SSC Service Bulletin

no. 82-284

MODELS AFFECTED: MCPH251A, 256A, 401A, 406A, 601A, 606A

SYMPTOMS: LOSS OF RECEIVER SENSITIVITY

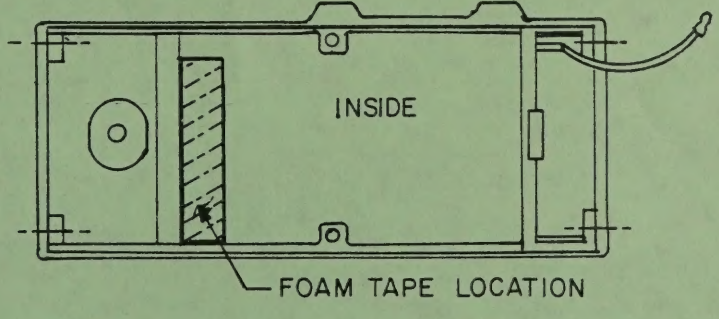
CAUSE: FAILURE OF R-4 AND/OR C-10 DUE TO VIBRATION OF P.C. BOARD

P/N 1601-1320-103, poly foam tape, will be installed in all future handhelds.

Attach poly foam tape to inside rear case as shown:
